St Quintin and Woodlands Neighbourhood Forum

Unit 9, Latimer Industrial Estate, 343 453 Latimer Road, LONDON, W10 6RQ PP/24/05920 – agenda item for Planning Committee May 1st

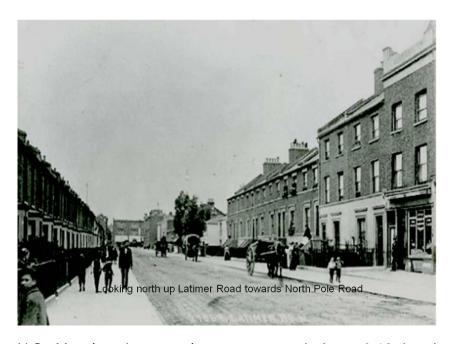
d) in a first set of pre-application advice issued by RBKC on redevelopment proposals for Unit 10 (dated 30/12/2021) RBKC officers commented as below:

'The Appeal decision for Unit 11 scheme PP/20/05721 dated 17/12/2021 means that four storeys plus set back fifth storey would no longer be acceptable due to the impact on townscape and the sense of enclosure. This overrides the earlier allowance in the Design Code for this height if supported by a light report. As such the proposed preapplication scheme is too high by one storey and proposals should be for a maximum of three above ground storeys plus set back fourth storey, as shown in the Model Plot diagram in the Design Guide'.
